# UNITED STATES PATENT AND TRADEMARK OFFICE

APPLICATION NO.	FILING DATE	FIRST NAMED INVENTOR	ATTORNEY DOCKET NO.	CONFIRMATION NO.
10/626,259	07/24/2003	Zhong Ding	961_013NP	9582
20874	7590	05/01/2007		
MARJAMA & BILINSKI LLP 250 SOUTH CLINTON STREET SUITE 300 SYRACUSE, NY 13202			EXAMINER GORDON, BRIAN R	
			ART UNIT 1743	PAPER NUMBER
			MAIL DATE 05/01/2007	DELIVERY MODE PAPER

## Office Action Summary

## **DETAILED ACTION**

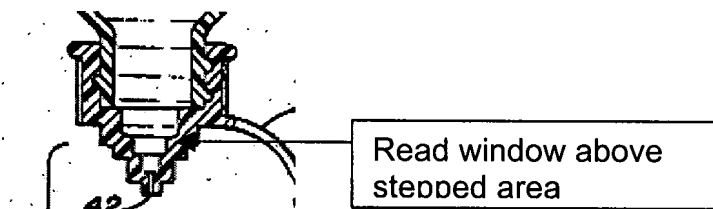
While it may be applicant intent to use the window to perform spectrophotometer analysis as stated, the only structural requirements of claims 1 and 6 are that the "window" be located above a stepped area. As previously indicated in the interview of March 12, 2007 out applicant's tip is a one piece integral structure in which applicant

simply chooses to select an section of the tip and refer to it as read window 96. The "read window" is not disclosed as being made of any different material or provided with any other structure that differentiates it from any other portion of the tip. If the entire tip allows for any viewing of material the may be therein, any portion one chooses can be referenced as a "read window". There is no requirement in the claims nor specification that applicant's read window has any specified dimensions as suggested.
